Iowa DAS - DOC 4JD CBC New Central Office Building

Addendum #01

Dated: April 30, 2026

ADDENDUM NUMBER ONE
To Contract Documents for:
IOWA DAS – DOC 4JD CBC NEW CENTRAL OFFICE BUILDING
SVPA Project No. 25079
Owner Project No. 9488.00

ROOF PLAN

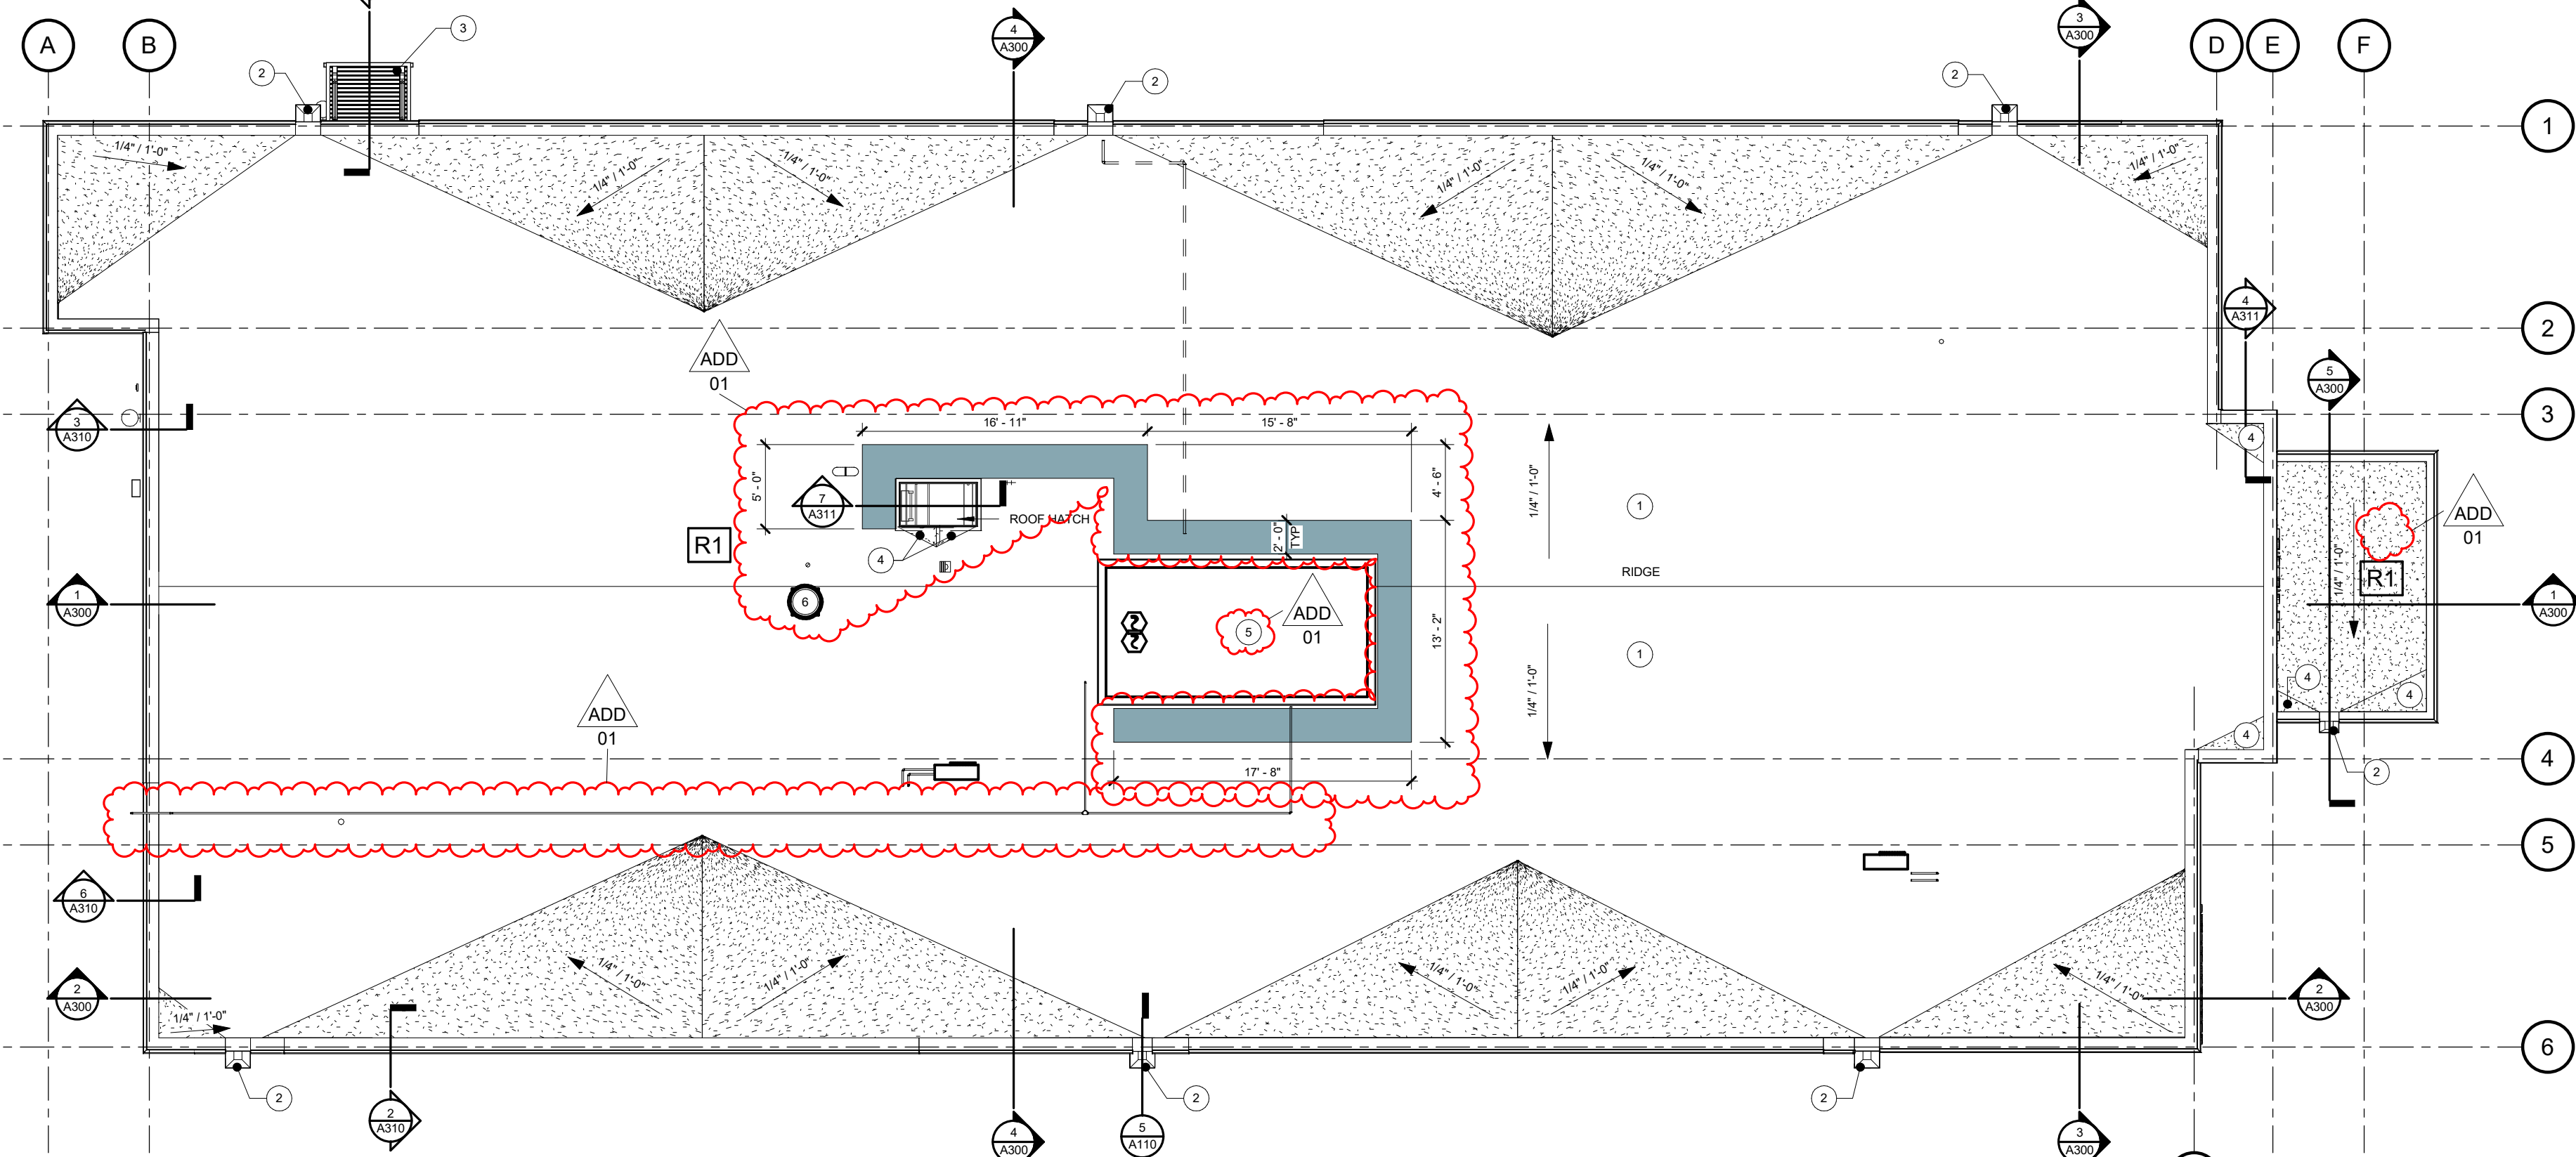
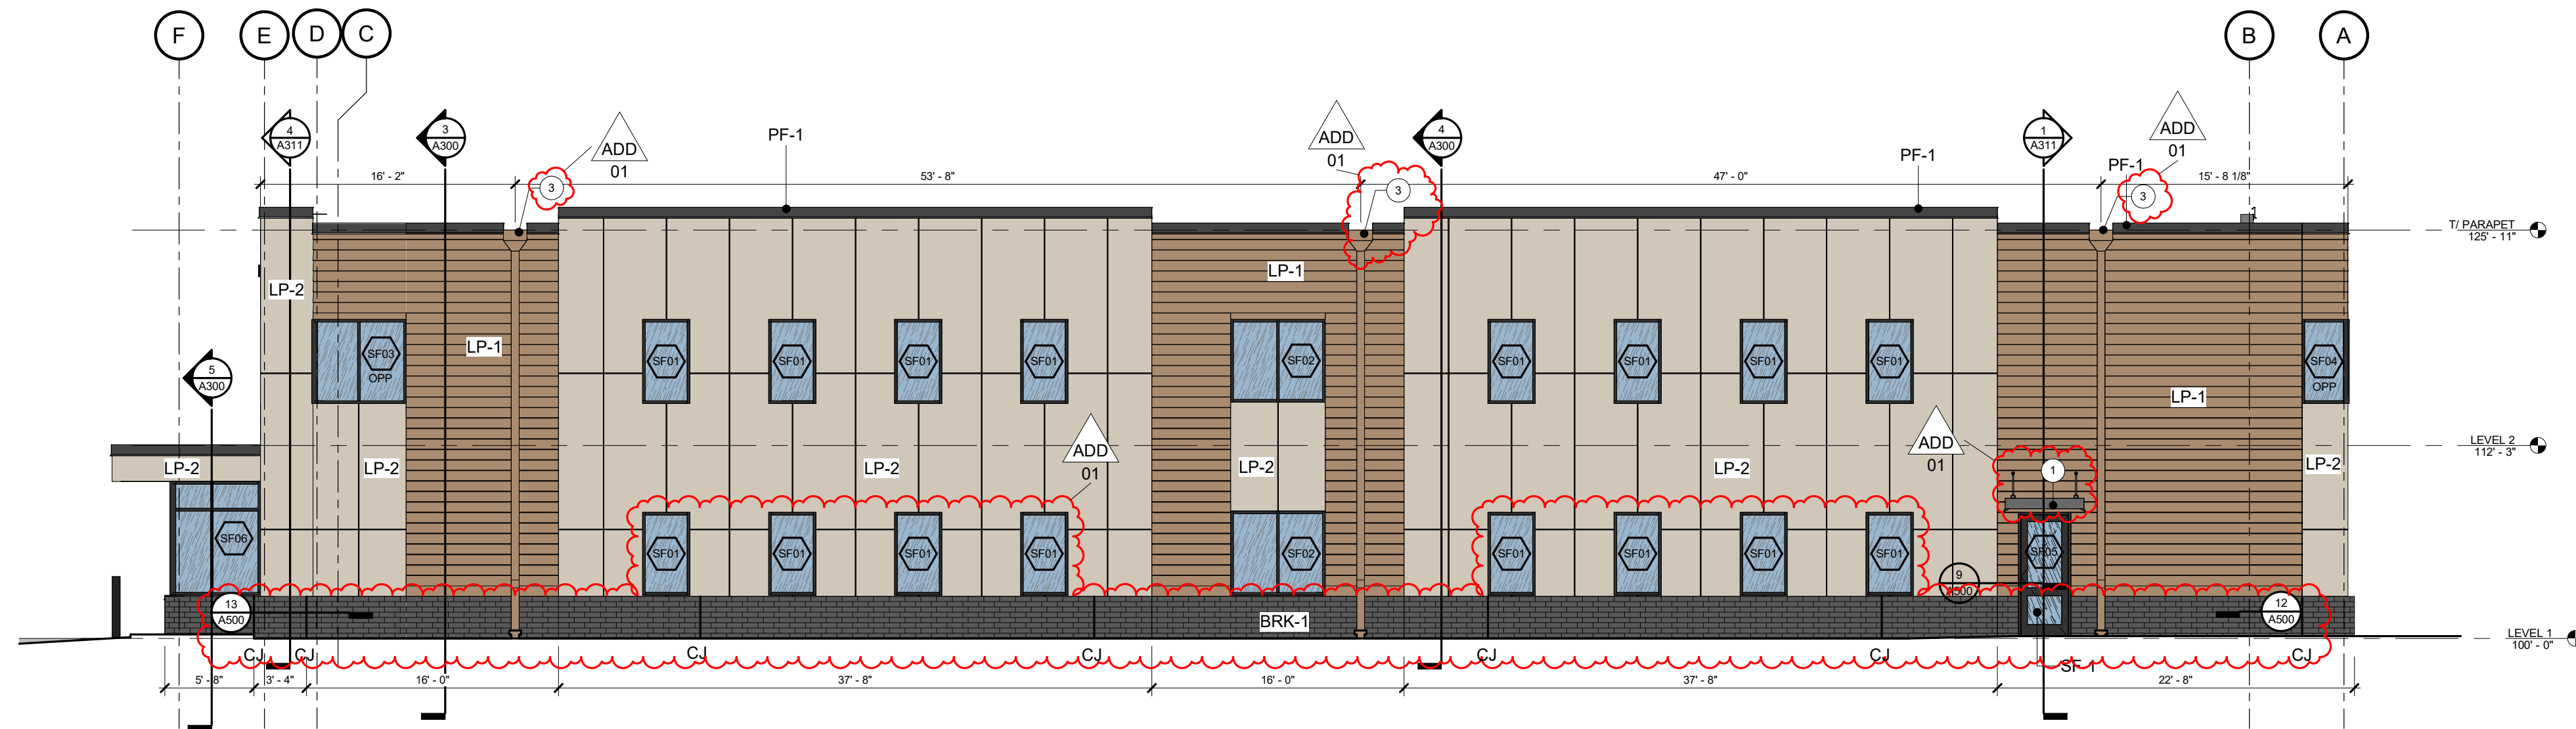
- C. REVISE elevation in GENERAL NOTES: FLOOR PLANS note 3.
 - D. See attached revised sheet A100.
8. **Sheet A110 – ROOF PLAN**
 - A. ADD Keynotes to ROOF PLAN NOTES.

- B. ADD dimensions to walkway pad and add keynotes to plan.
 - C. ADD Detail View 7: CANOPY DETAIL 2 to sheet.
 - D. REVISE detail keynotes.
 - E. REVISE structural connection at walls – details 2 and 3.

- F. REMOVE roof drain from ROOF LEGEND.
 - G. REVISE gas line location – see MECHANICAL.
 - H. See attached revised sheet A110.

1 NORTH ELEVATION
SCALE: 1/8" = 1'-0"

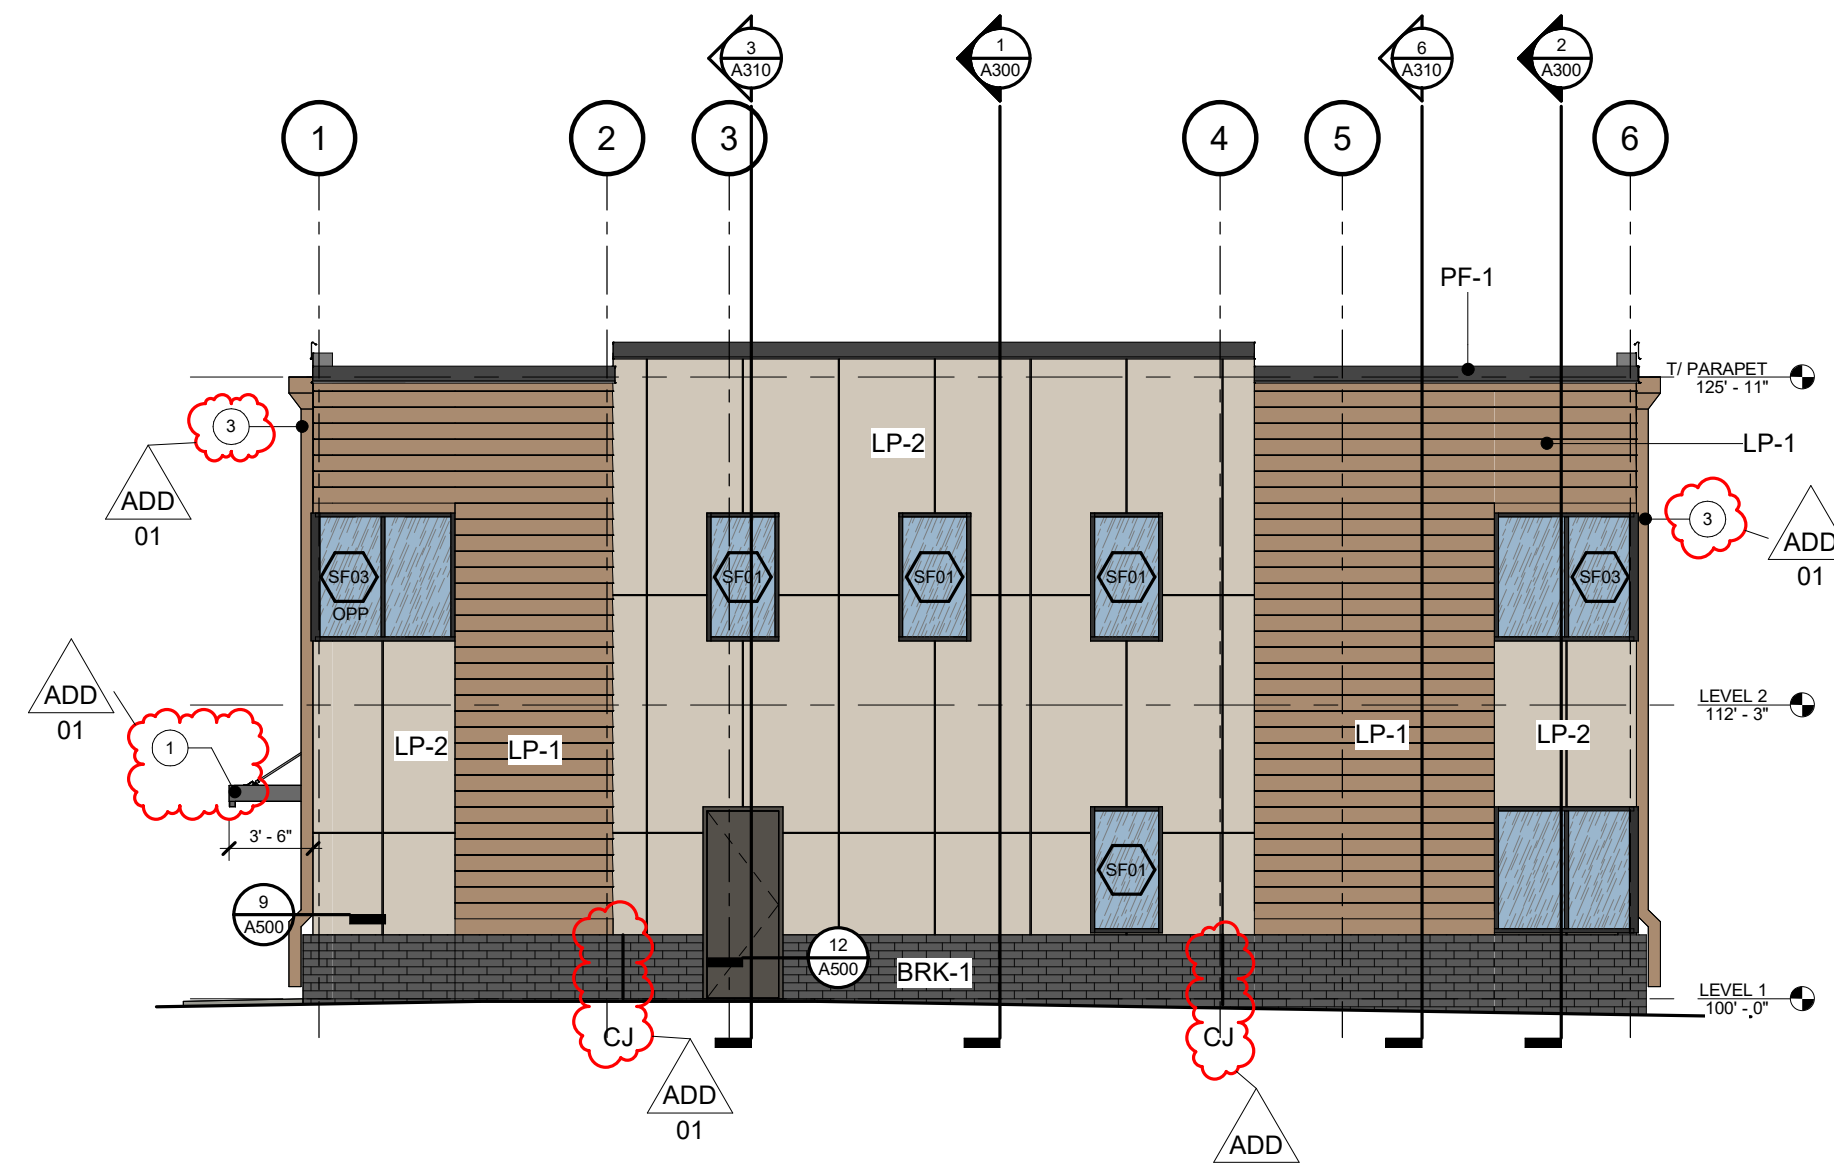
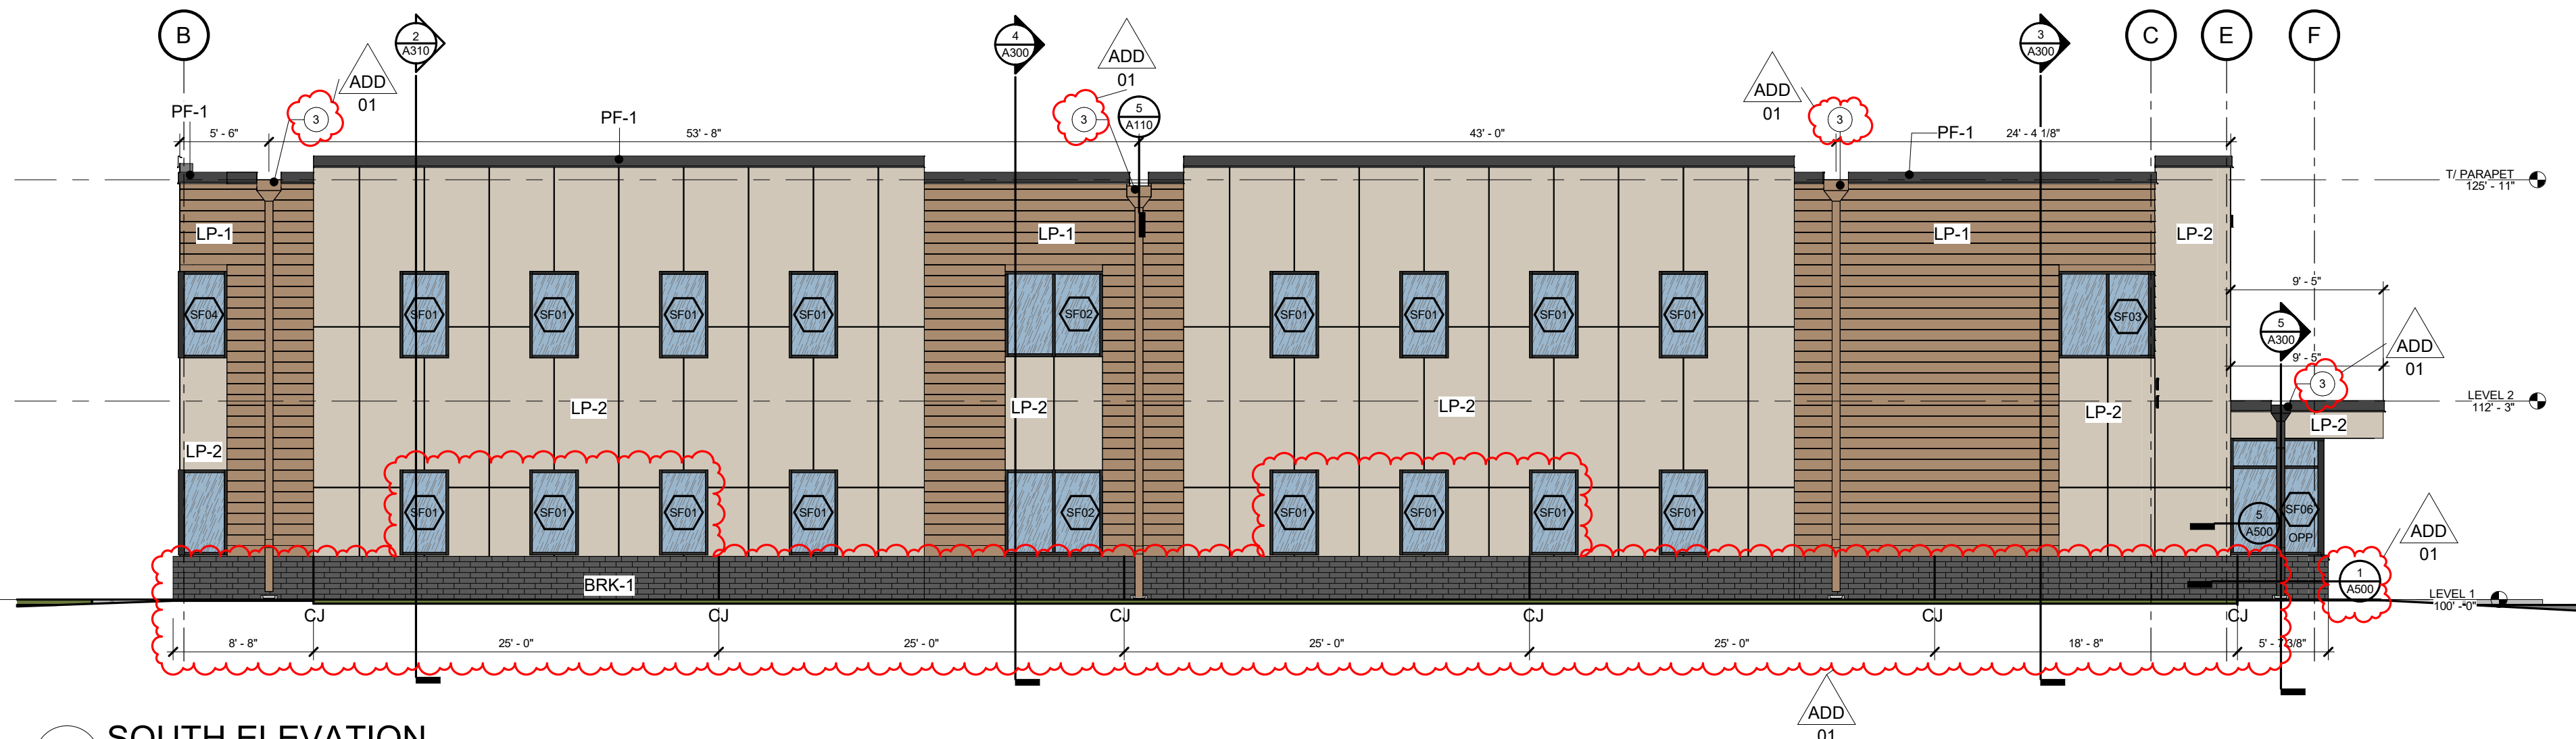
- A. ADD EXTERIOR ELEVATION NOTES to sheet.
- B. ADD keynotes to elevations.
- C. REVISE control joint locations.
- D. ADD storefront jambs to elevations.
- E. See attached revised sheet A200.
